City of Seattle

DESIRABLE LOCATIONS FOR UTILITIES (RESIDENTIAL STREET)

CURB RAMP DETAILS

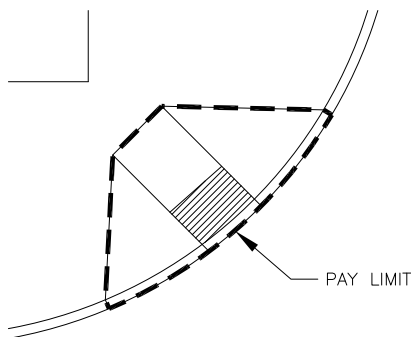
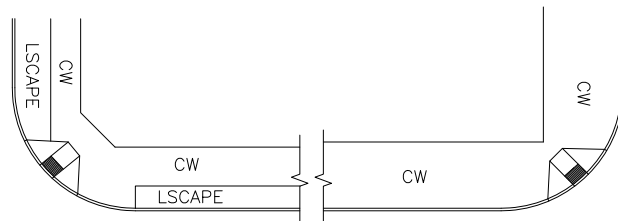
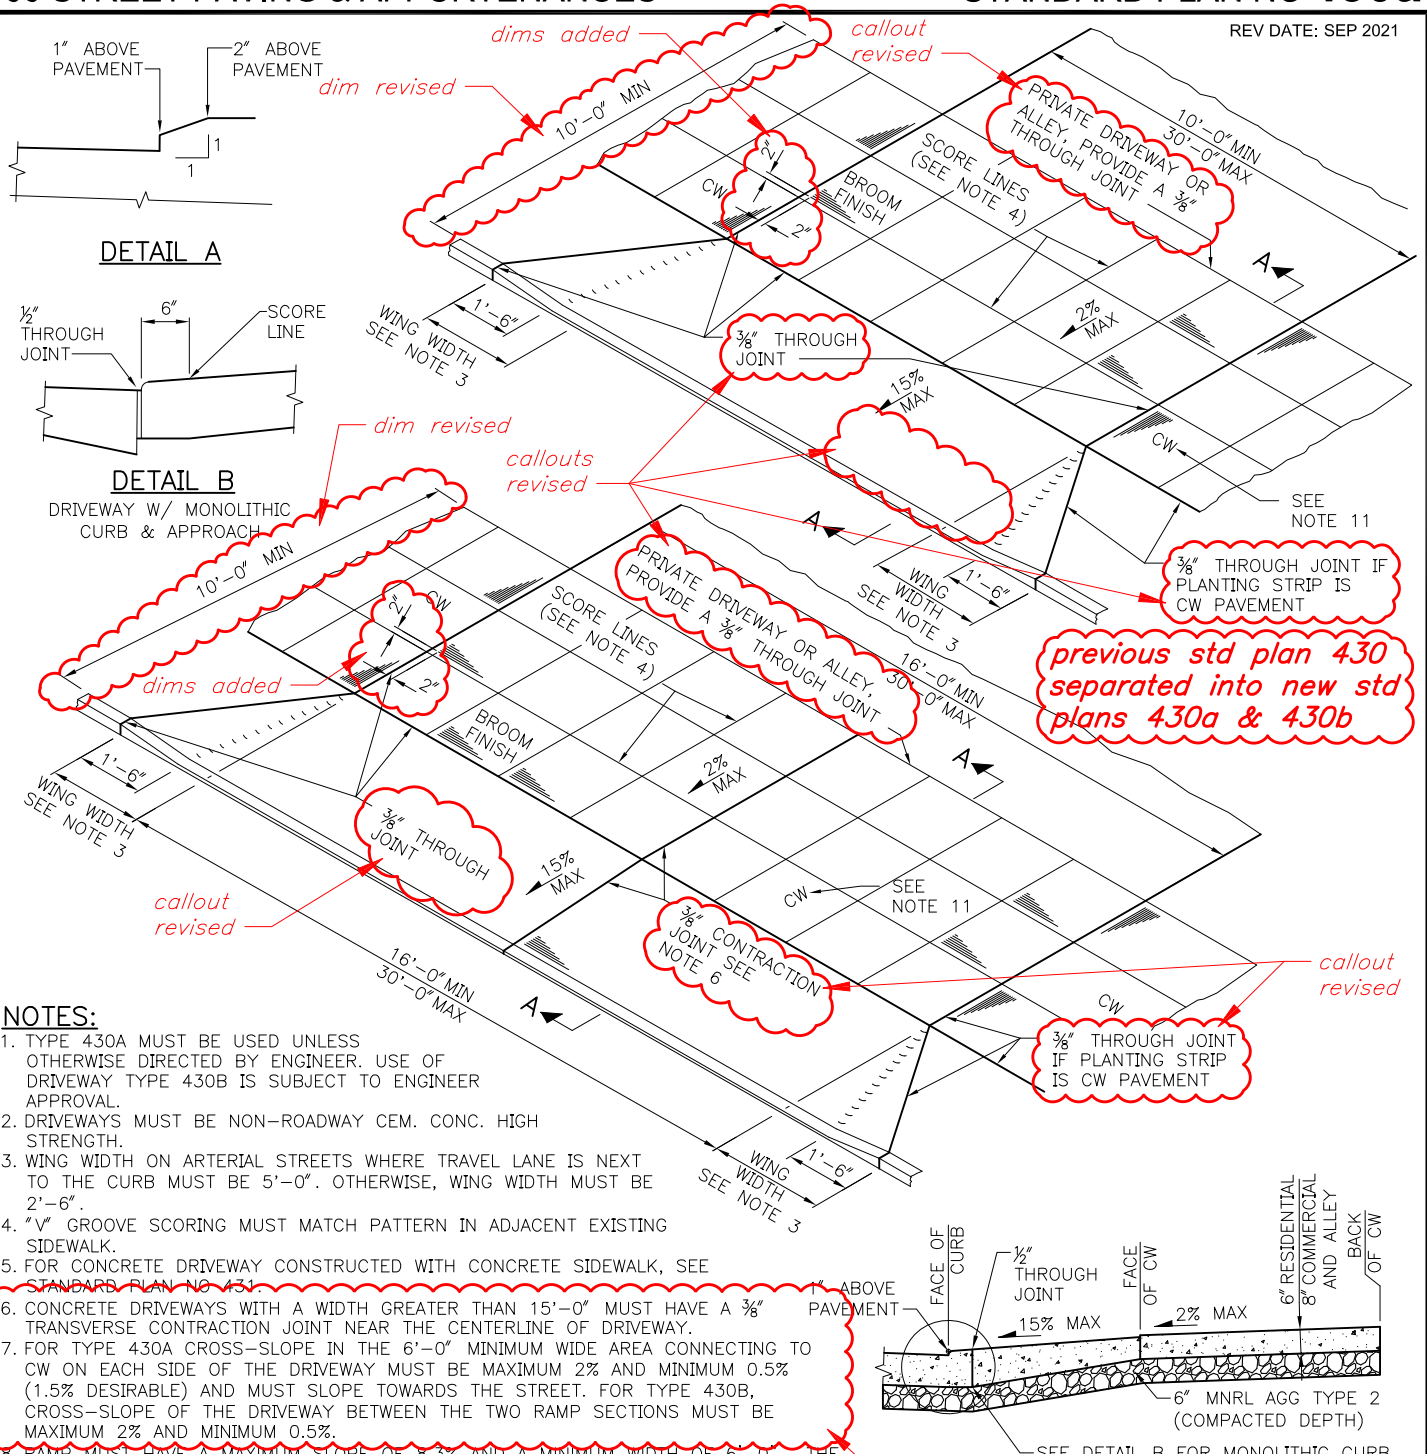
curb return redrafted to allow for clear space to fall within extended face of curb

3. CLEAR SPACE AT THE BOTTOM OF THE RAMP MUST BE 5'-0" MINIMUM IN WIDTH AND MUST EXTEND A MINIMUM OF 4'-0" BEYOND THE RAMP LOWER GRADE BREAK. THE CLEAR SPACE MUST FALL WHOLLY WITHIN THE LEGAL CROSSWALK, MARKED OR UNMARKED. THE CLEAR SPACE MUST FIT BEHIND LINES EXTENDING FROM THE FACE OF CURB RUNNING PARALLEL TO EACH ROADWAY. THERE IS NO ALLOWABLE EXEMPTION FOR MINIMUM CLEAR SPACE REQUIREMENTS AT SHARED DIAGONAL PERPENDICULAR CURB RAMP.

TYPE 430A DRIVEWAY

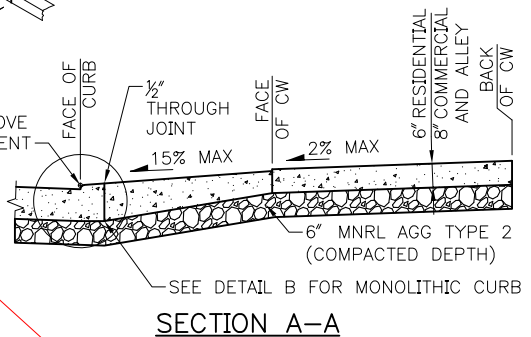
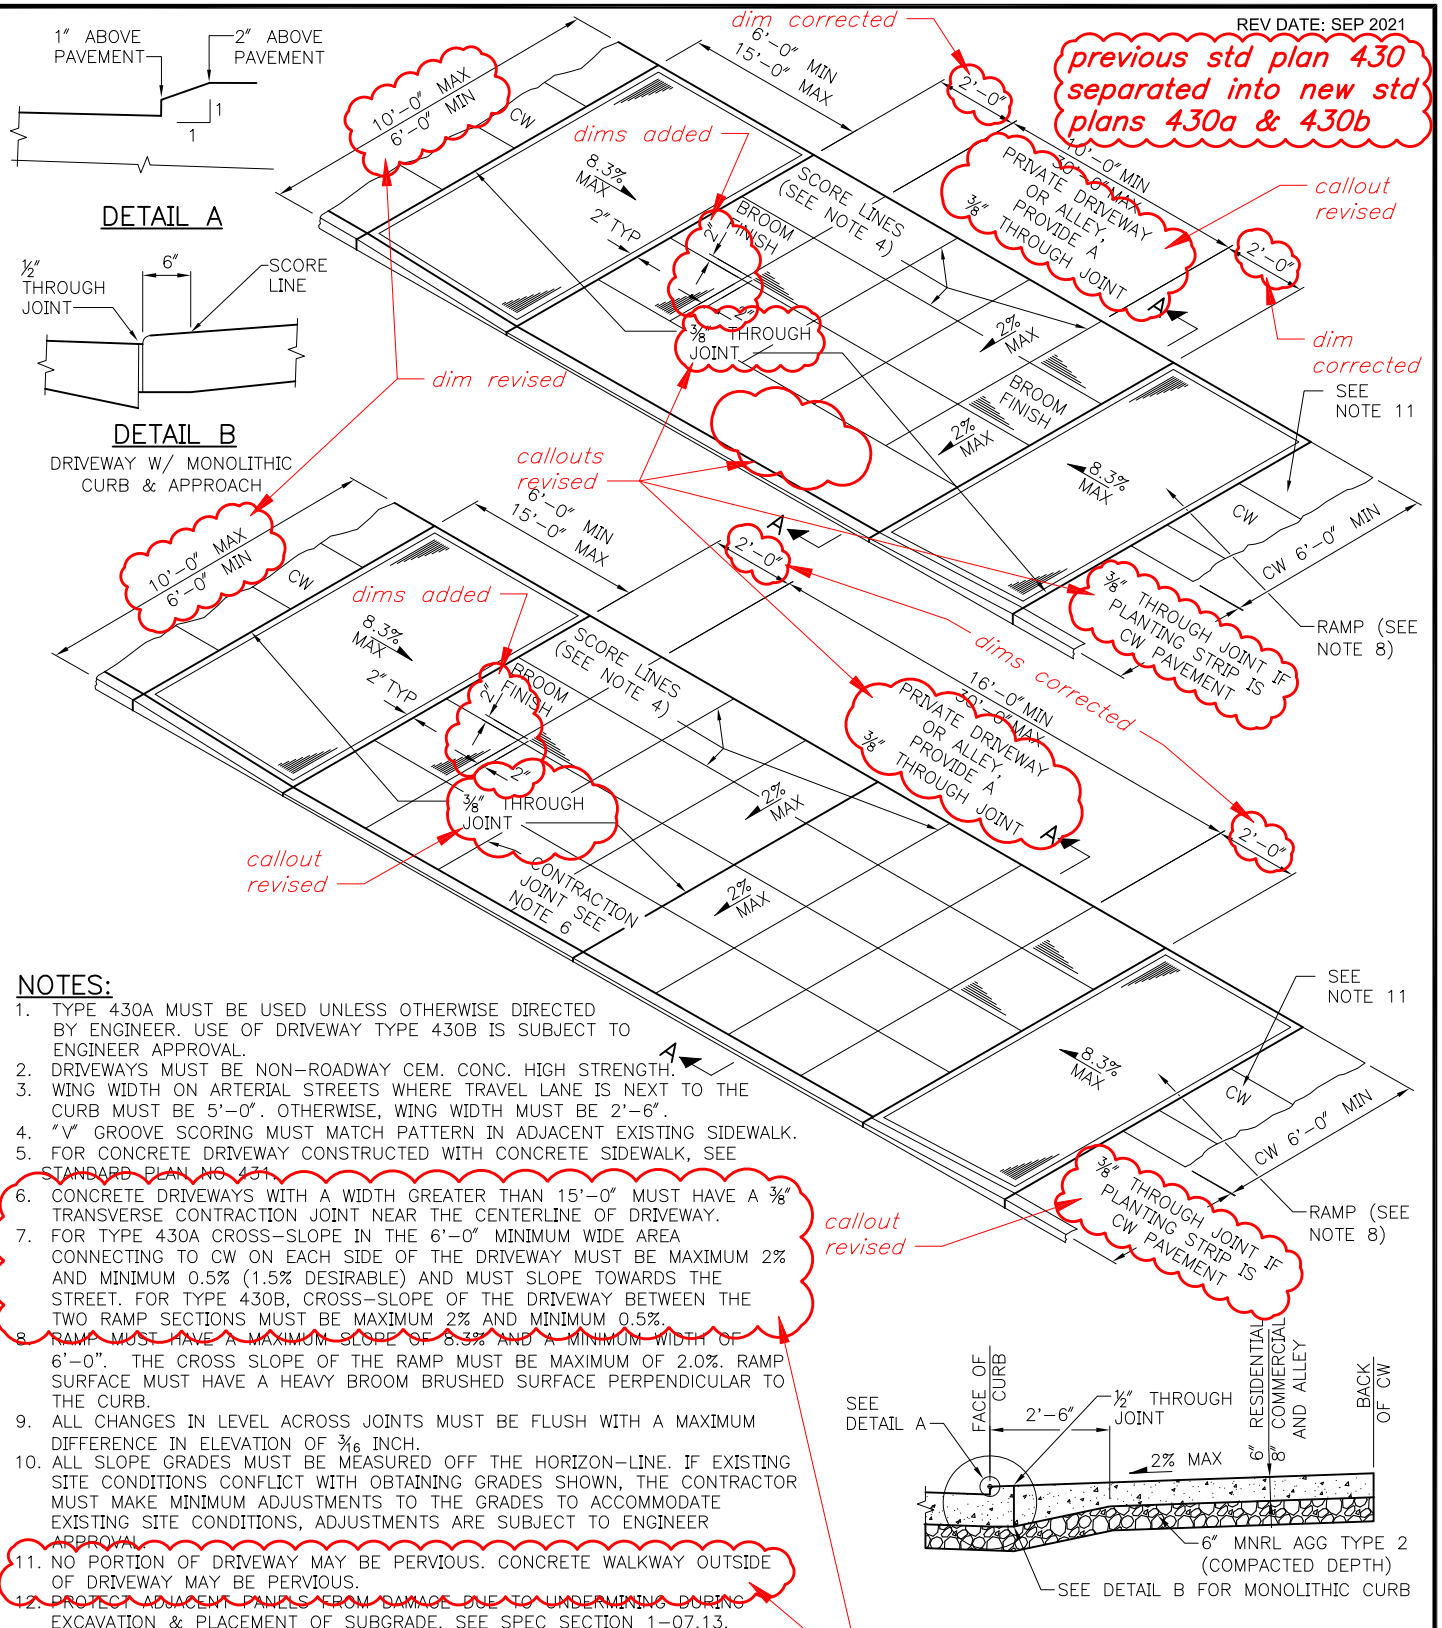
notes 6, 7 & 11 revised

5. FOR CONCRETE DRIVEWAY CONSTRUCTED WITH CONCRETE SIDEWALK, SEE STANDARD PLAN NO 431.
6. CONCRETE DRIVEWAYS WITH A WIDTH GREATER THAN 15'-0" MUST HAVE A 3/8" TRANSVERSE CONTRACTION JOINT NEAR THE CENTERLINE OF DRIVEWAY.

7. FOR TYPE 430A CROSS-SLOPE IN THE 6'-0" MINIMUM WIDE AREA CONNECTING TO CW ON EACH SIDE OF THE DRIVEWAY MUST BE MAXIMUM 2% AND MINIMUM 0.5% (1.5% DESIRABLE) AND MUST SLOPE TOWARDS THE STREET. FOR TYPE 430B, CROSS-SLOPE OF THE DRIVEWAY BETWEEN THE TWO RAMP SECTIONS MUST BE MAXIMUM 2% AND MINIMUM 0.5%.

11. CONCRETE WALKWAY OUTSIDE OF THE DRIVEWAY CROSSING MAY BE PERVIOUS.
12. PROTECT ADJACENT PANELS FROM DAMAGE DUE TO UNDERMINING DURING EXCAVATION & PLACEMENT OF SUBGRADE. SEE SPEC SECTION 1-07.13.

TYPE 430B DRIVEWAY

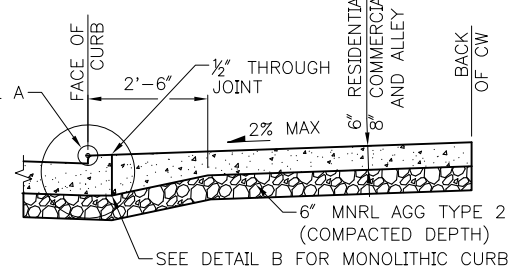
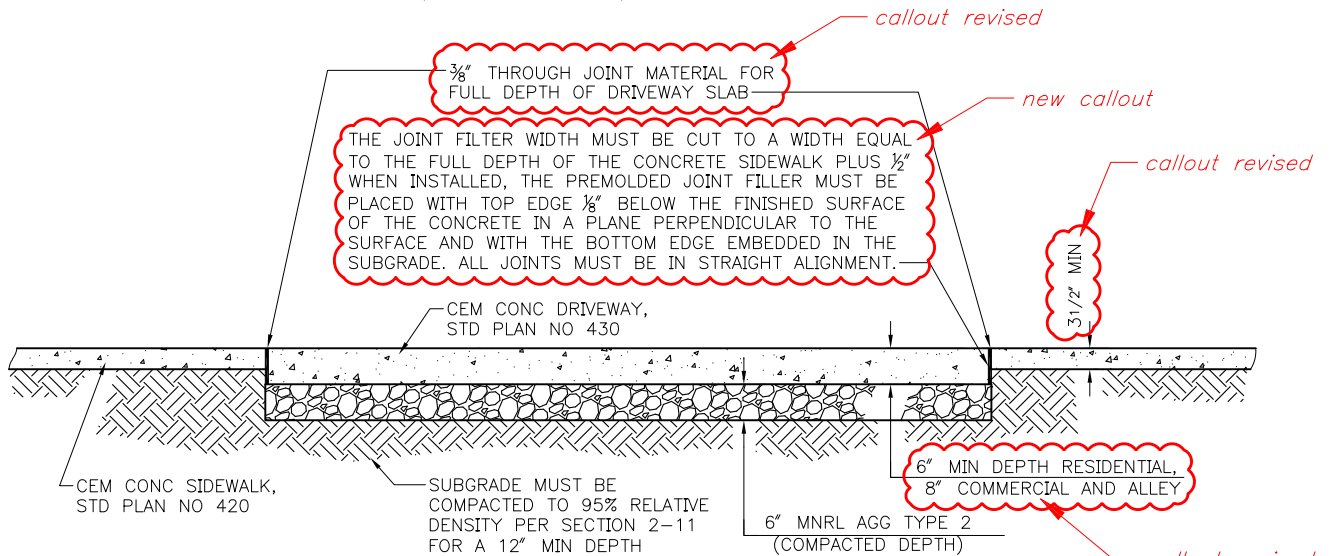
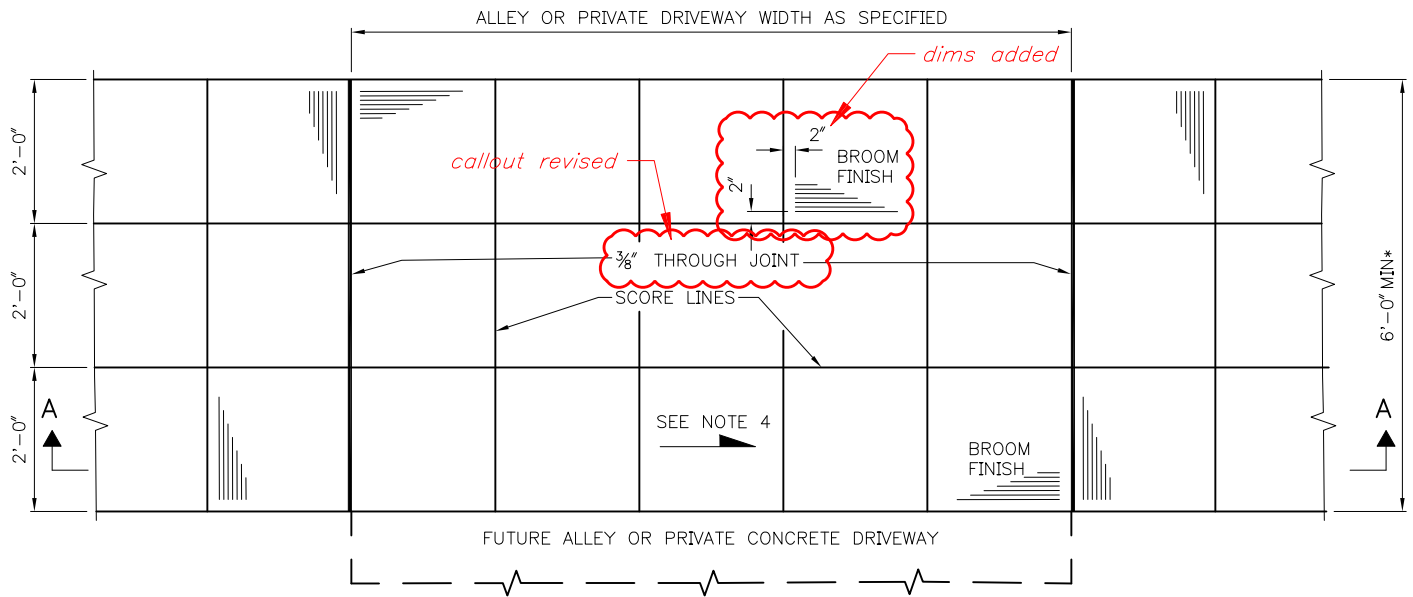
callout revised

notes 6, 7 & 11 revised

5. FOR CONCRETE DRIVEWAY CONSTRUCTED WITH CONCRETE SIDEWALK, SEE STANDARD PLAN NO 431.
6. CONCRETE DRIVEWAYS WITH A WIDTH GREATER THAN 15'-0" MUST HAVE A 3/8" TRANSVERSE CONTRACTION JOINT NEAR THE CENTERLINE OF DRIVEWAY.

7. FOR TYPE 430A CROSS-SLOPE IN THE 6'-0" MINIMUM WIDE AREA CONNECTING TO CW ON EACH SIDE OF THE DRIVEWAY MUST BE MAXIMUM 2% AND MINIMUM 0.5% (1.5% DESIRABLE) AND MUST SLOPE TOWARDS THE STREET. FOR TYPE 430B, CROSS-SLOPE OF THE DRIVEWAY BETWEEN THE TWO RAMP SECTIONS MUST BE MAXIMUM 2% AND MINIMUM 0.5%.

11. NO PORTION OF DRIVEWAY MAY BE PERVIOUS. CONCRETE WALKWAY OUTSIDE OF DRIVEWAY MAY BE PERVIOUS.
12. PROTECT ADJACENT PANELS FROM DAMAGE DUE TO UNDERMINING DURING EXCAVATION & PLACEMENT OF SUBGRADE. SEE SPEC SECTION 1-07.13.

TRAFFIC SIGNAL POLE FOUNDATION DETAIL

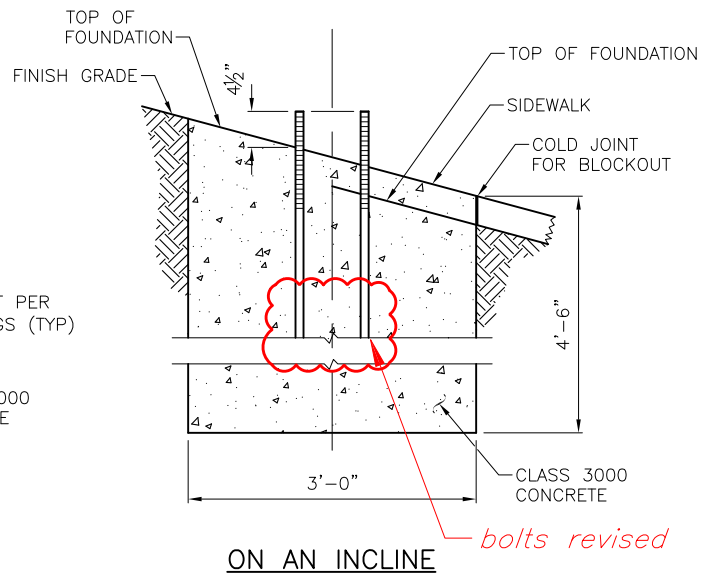
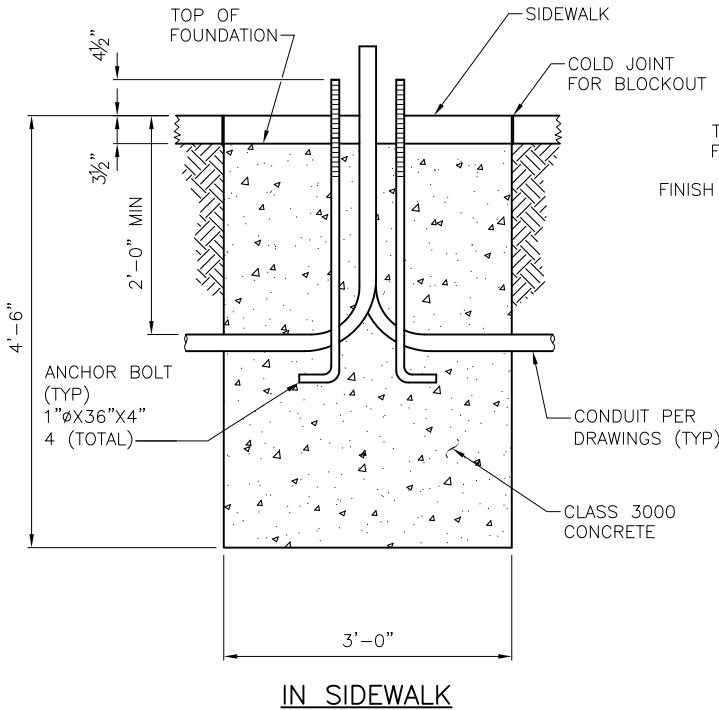
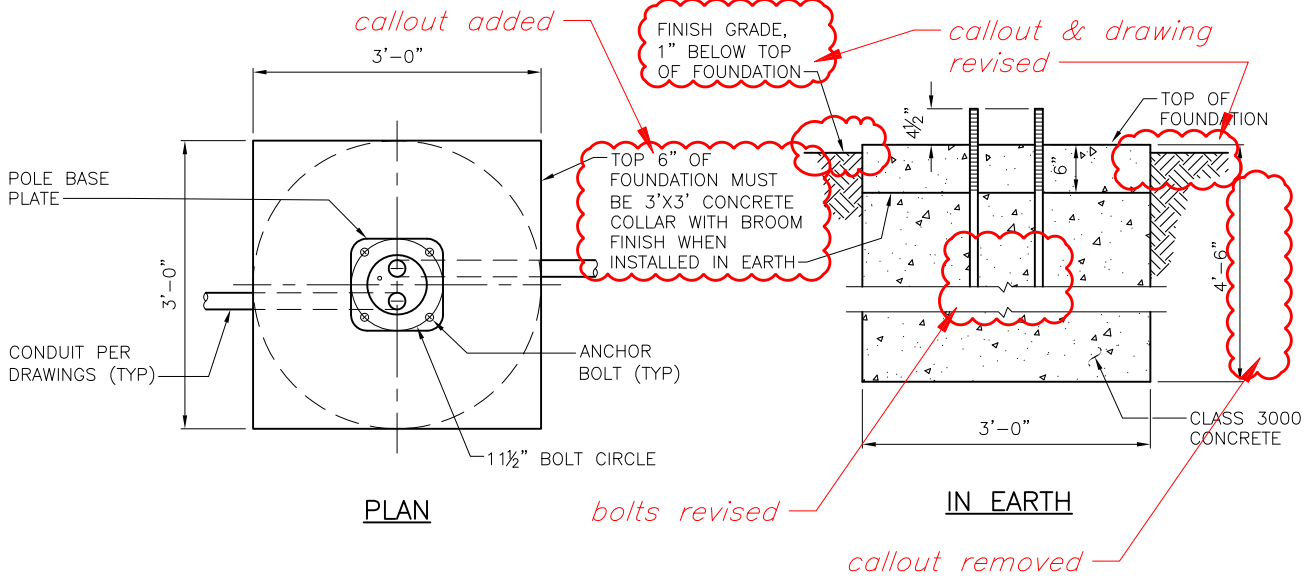
former note 1 removed

note added

1. SEE SCL CONSTRUCTION STANDARD 1716.34 FOR POLE MOUNTING AND GROUT DETAIL
2. ANCHOR BOLTS MUST BE HOT DIP GALVANIZED ASTM A153 OR F2329, FULL LENGTH AND FABRICATED FROM ASTM F1554 OR A576 WITH 12" THREADS ON TOP
3. ALL SHRUBBERY AND FOLIAGE MUST BE PLANTED A MINIMUM OF 2' FROM SCL STRUCTURE PER SCL CONSTRUCTION STANDARD 0214.00

STREET LIGHT
POLE FOUNDATIONS

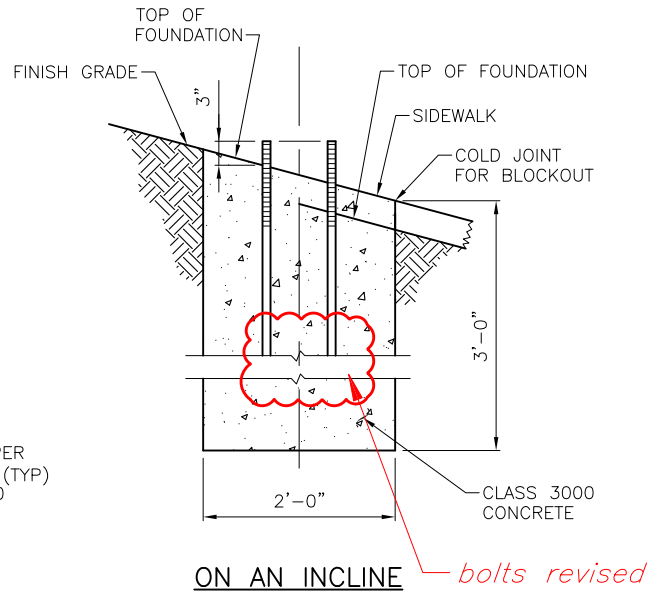
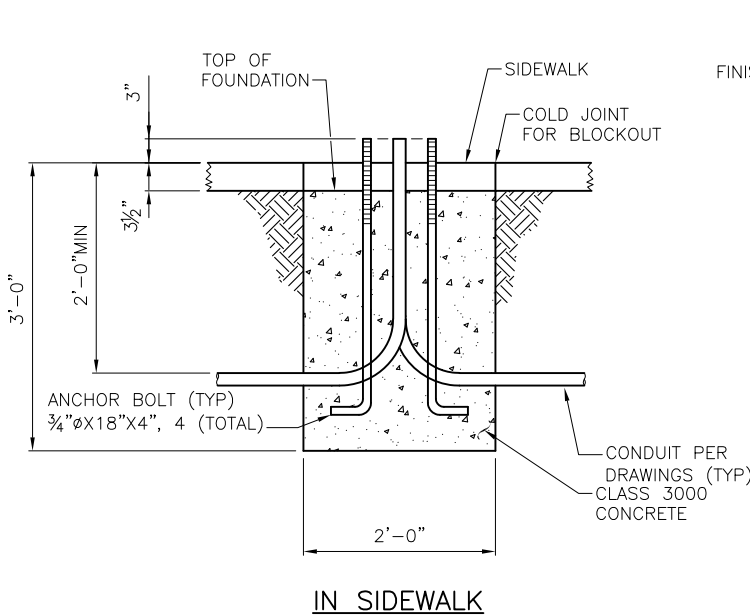
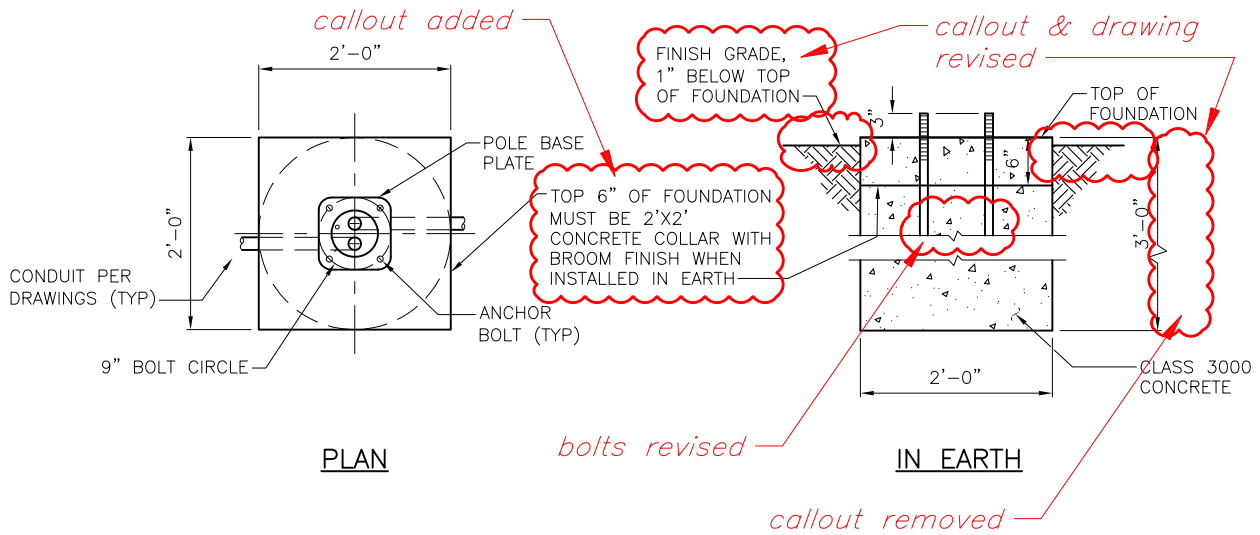
former note 1 removed

note added

1. SEE SCL CONSTRUCTION STANDARD 1716.34 FOR POLE MOUNTING AND GROUT DETAIL
2. ANCHOR BOLTS MUST BE HOT DIP GALVANIZED TO ASTM A153 OR F2329, FULL LENGTH AND FABRICATED FROM ASTM F1554 OR A576 WITH 8" OF THREADS ON TOP
3. SEE SCL MATERIAL STANDARD 5756.09 FOR POLES
4. SEE SCL CONSTRUCTION STANDARD 1716.07 FOR STREETLIGHT HANDHOLE AND CONDUIT REQUIREMENTS.
5. ALL SHRUBBERY AND FOLIAGE MUST BE PLANTED A MINIMUM OF 2' FROM SCL STRUCTURE PER SCL CONSTRUCTION STANDARD 0214.00
